# CONVAIR

## COMMERCIAL CHANGE PROPOSAL

SPEC NO.: ZD- 22-003

MODEL: 22-2 (Convair "880")

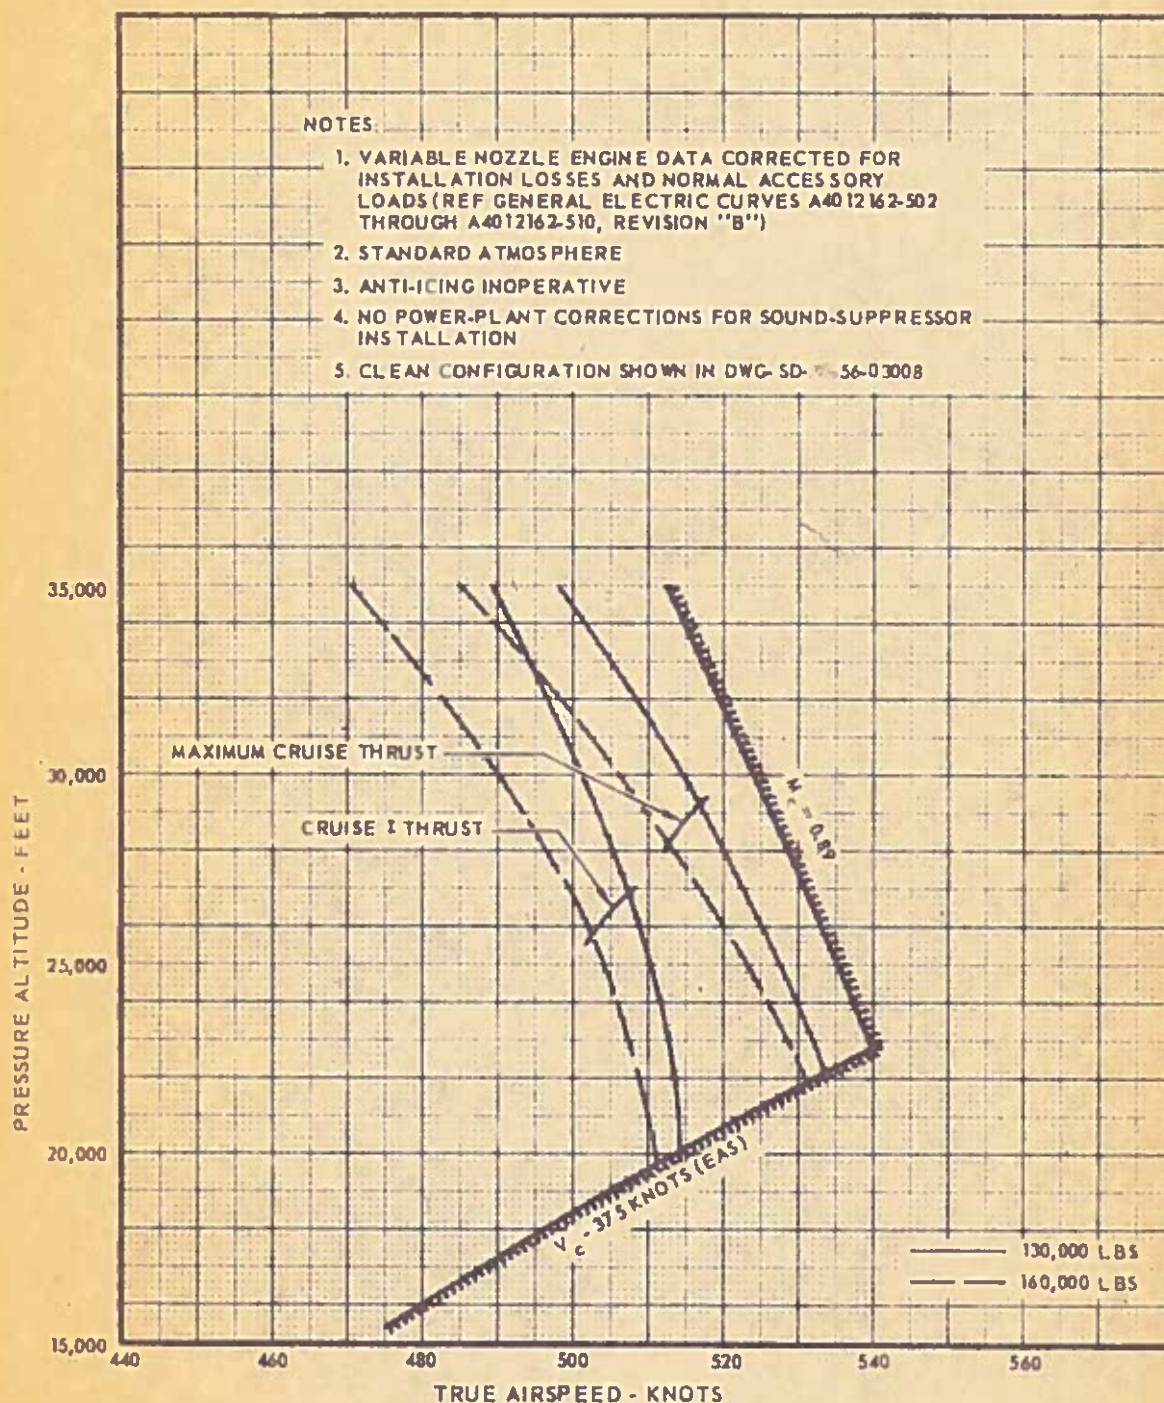
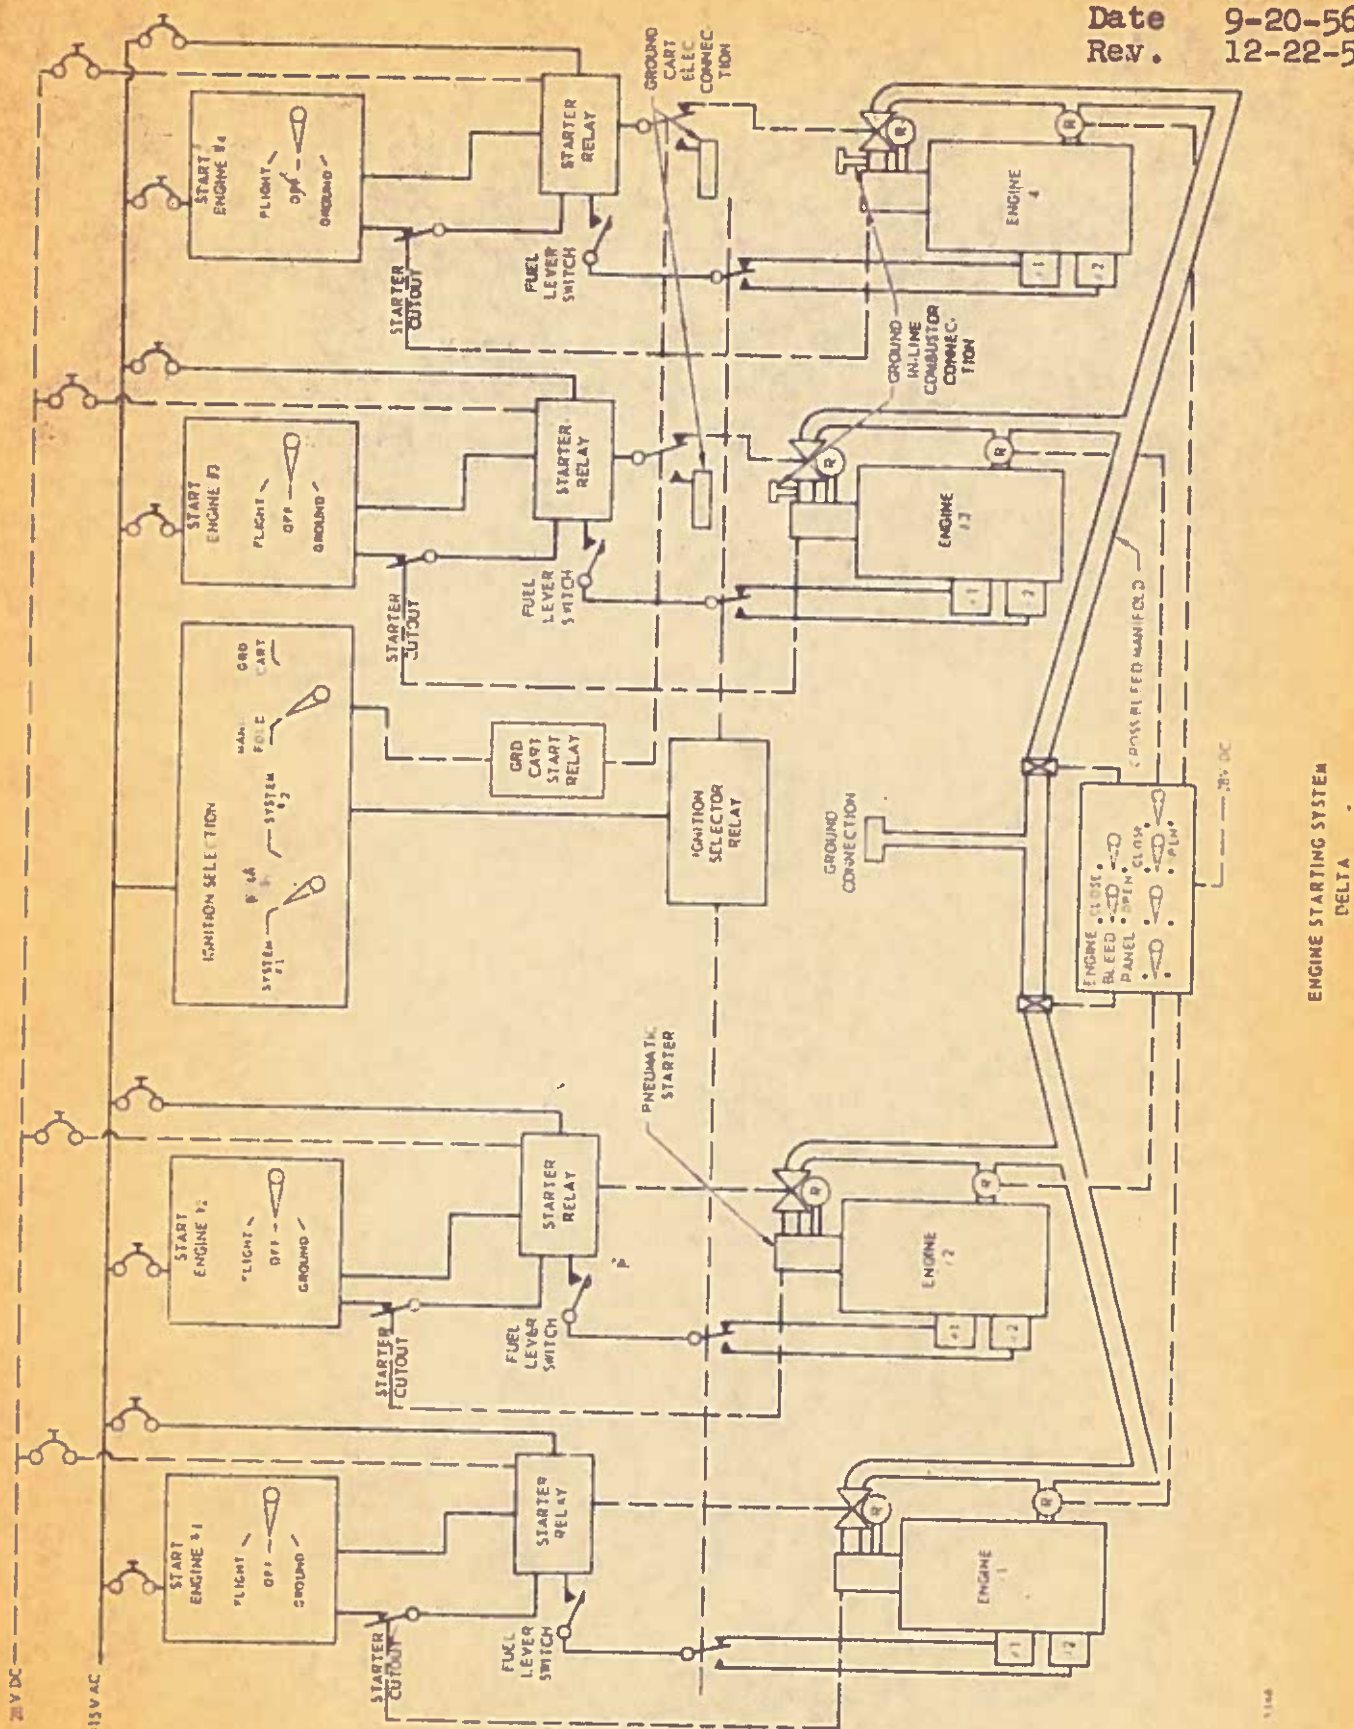
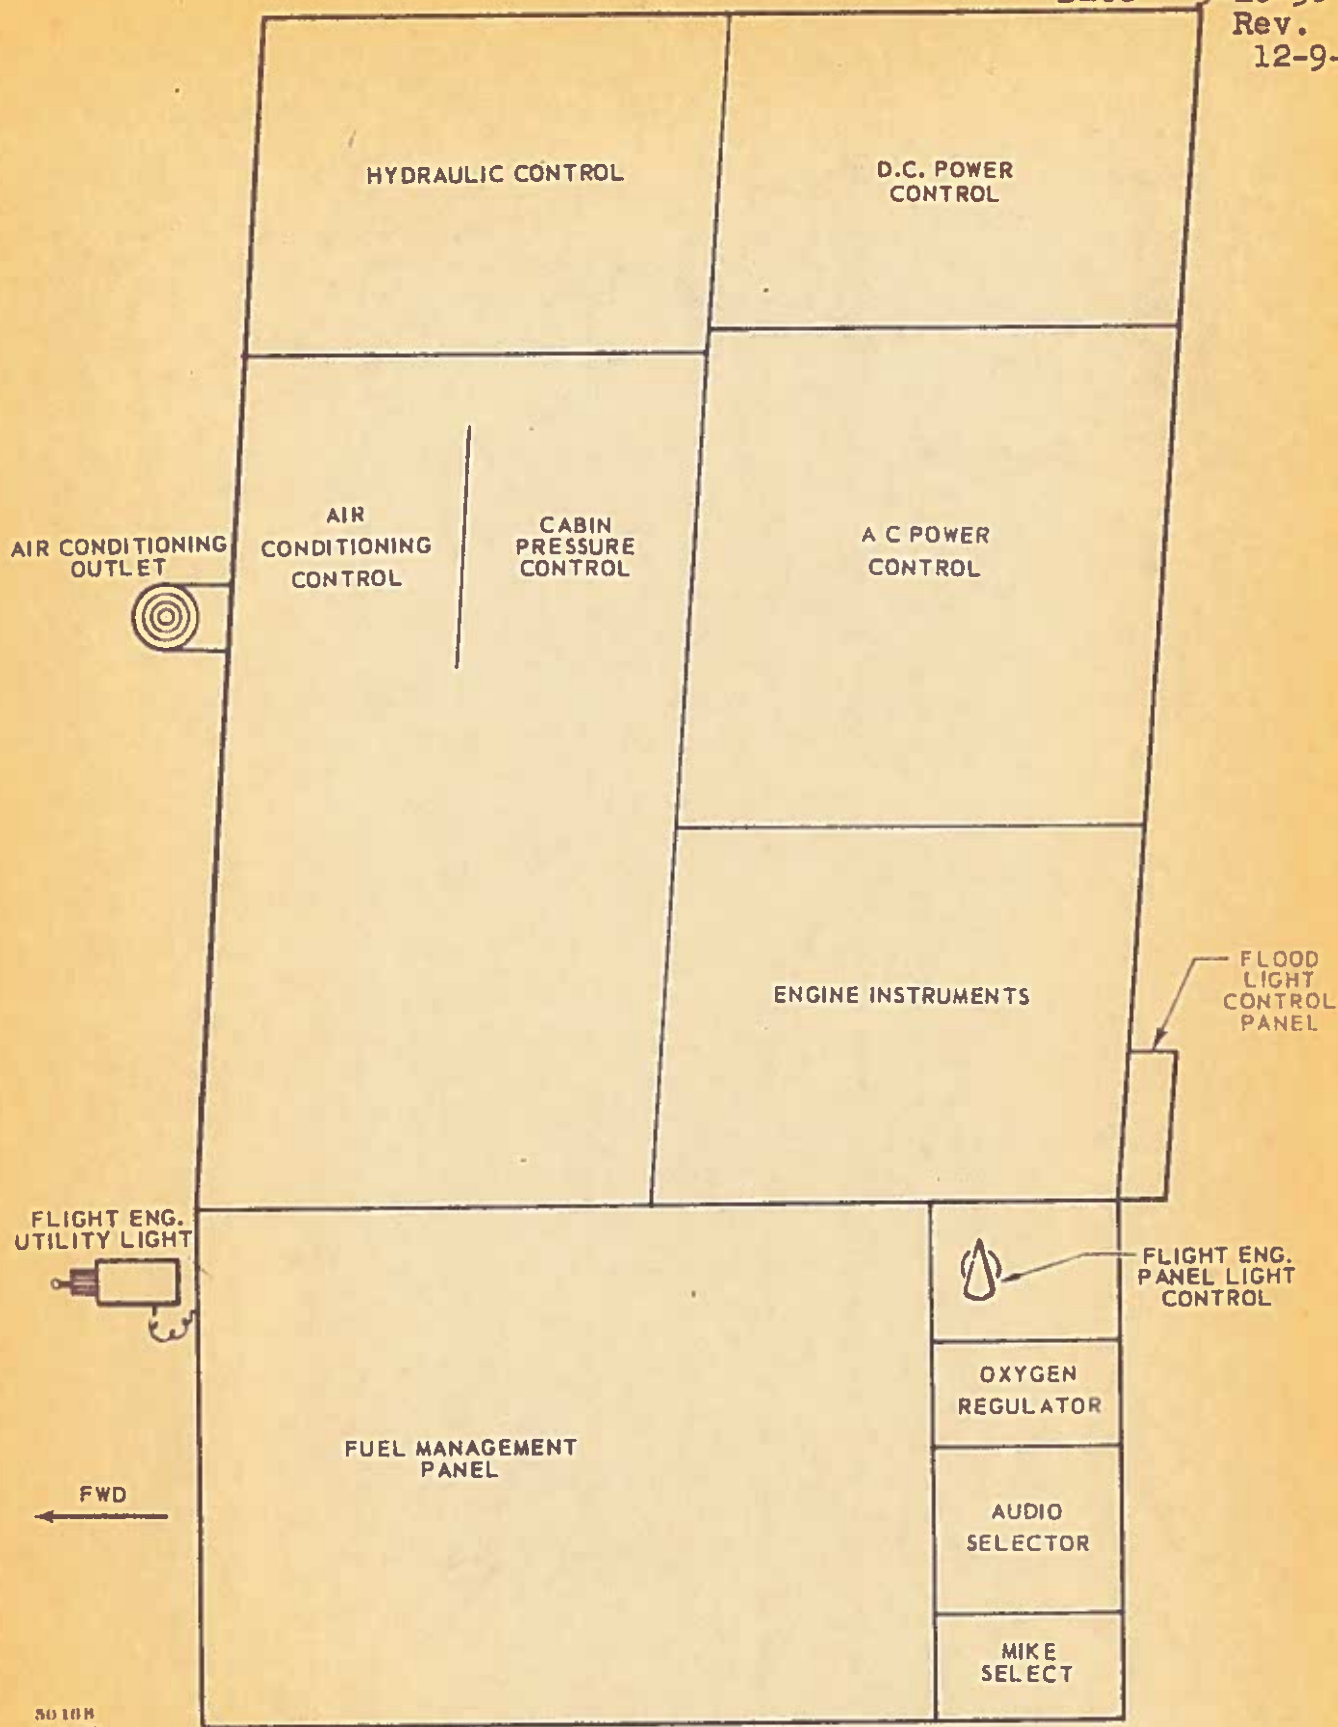
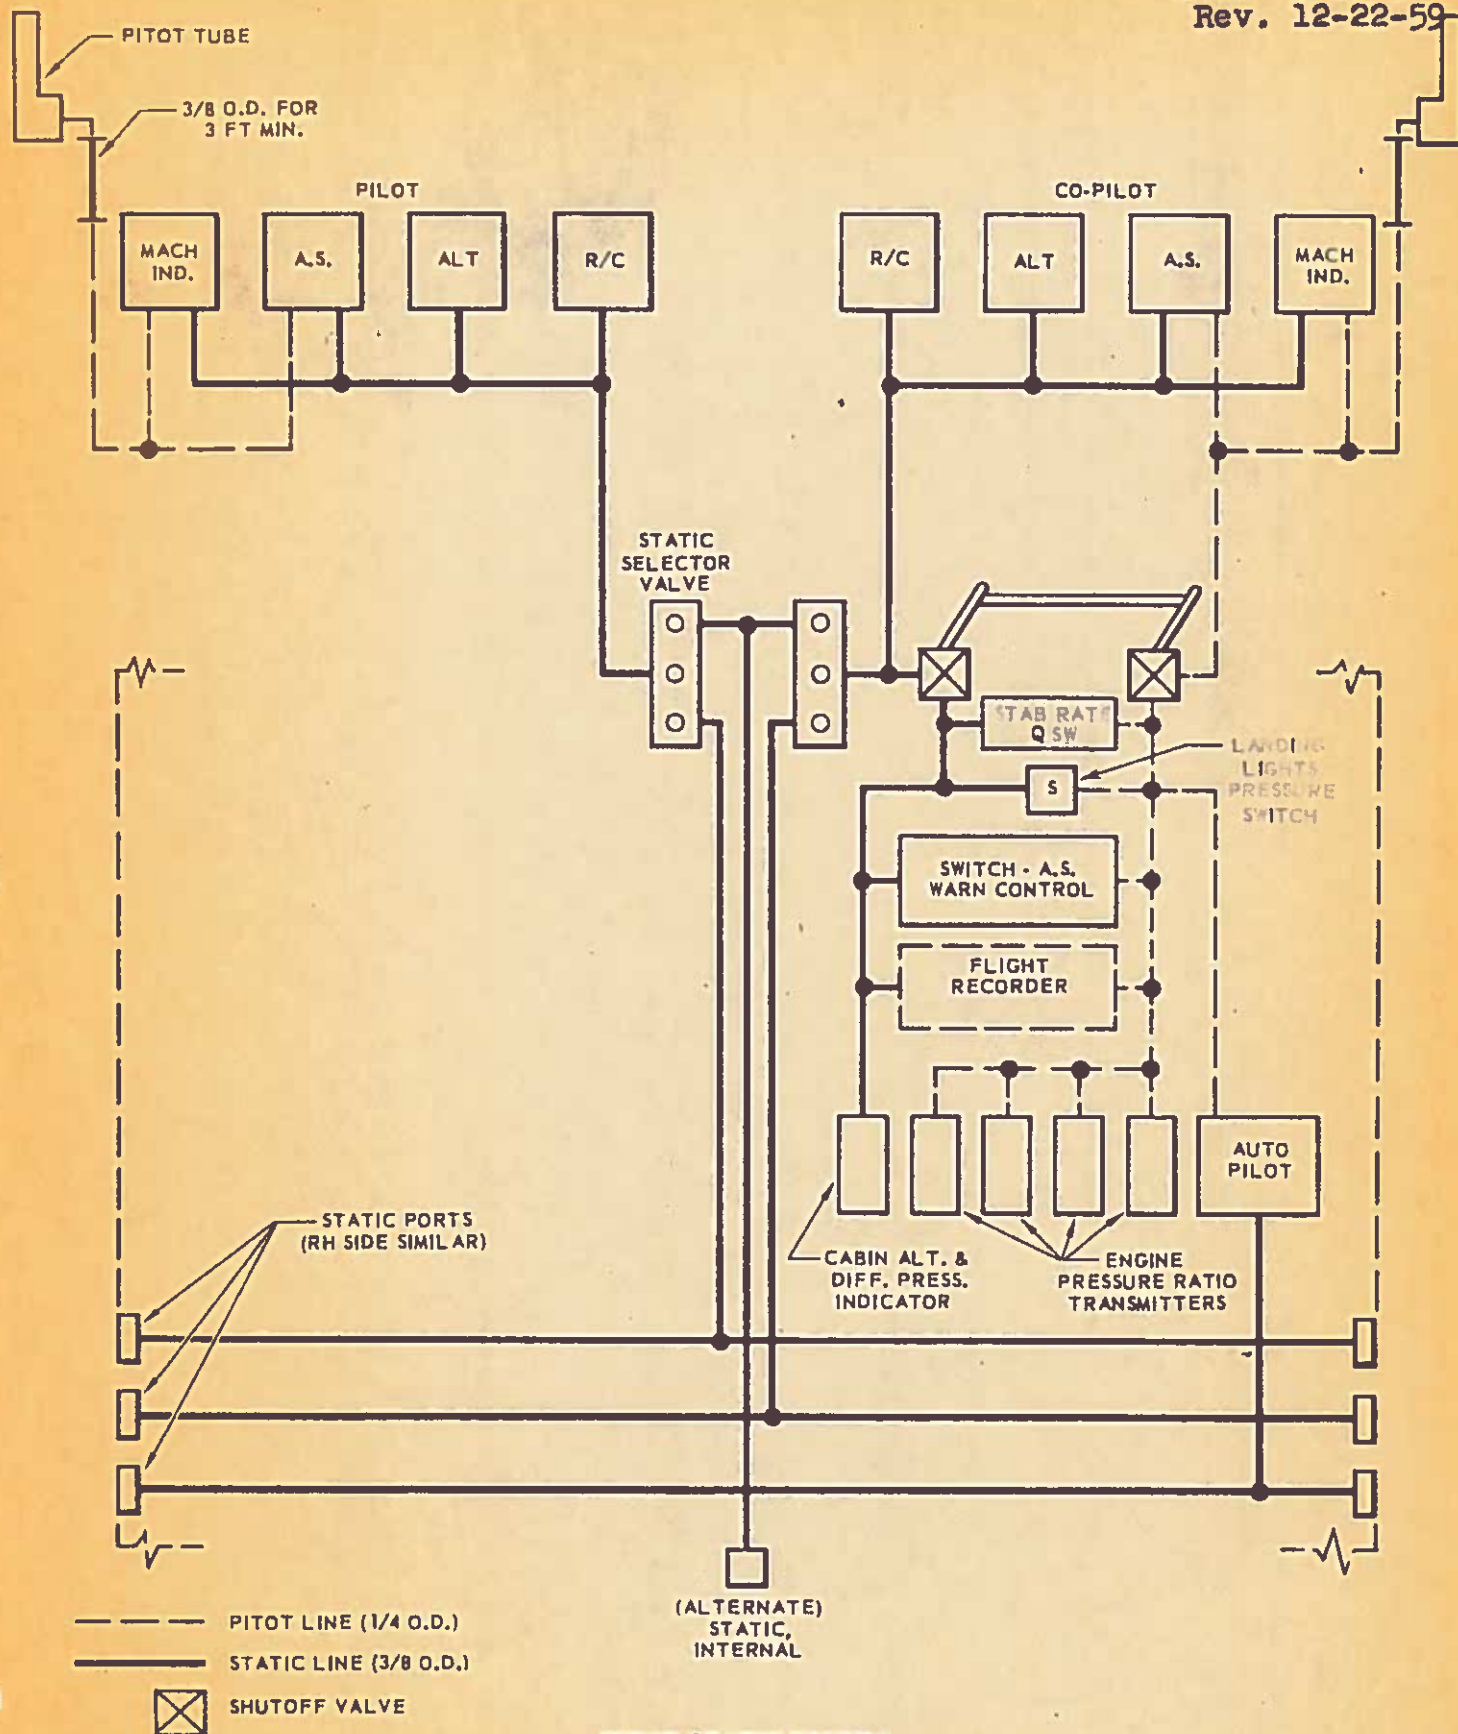
Reason for Change: To replace obsolescent and illegible illustrations.

One revised copy each of the above illustrations is attached hereto for Customer approval and subsequent incorporation into specification.
